Ch-Ch-Ch-Ch-Changes!

Get out those stubby pencils, crewmen. It's time to make a change to your M1A1 tank's -10-1 TM.

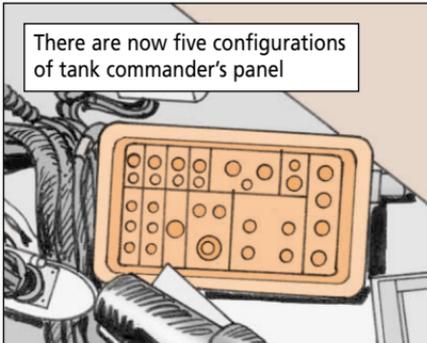
YEP! YOU MAY
HAVE ONE OF
FIVE DIFFERENT
CONFIGURATIONS
OF THE TANK COM-
MANDER'S PANEL.

Page 1-45 on the tank's NBC system says there are only three configurations of the tank commander's panel. But now there are five.

There are now five configurations
of tank commander's panel

So, until the TM is updated, replace Para 2 with the following:

“There are five configurations of the tank commander's panel. Part numbers 9376322 and 9377879 will start NBC System when engine starts unless turret networks box circuit breaker CB3 is turned off. Part numbers 12549797, 12549797-2, and 12549797-3 will not start NBC System automatically.”

YOU'LL FIND
THE PART NUMBER
ON THE PANEL'S
DATA PLATE.
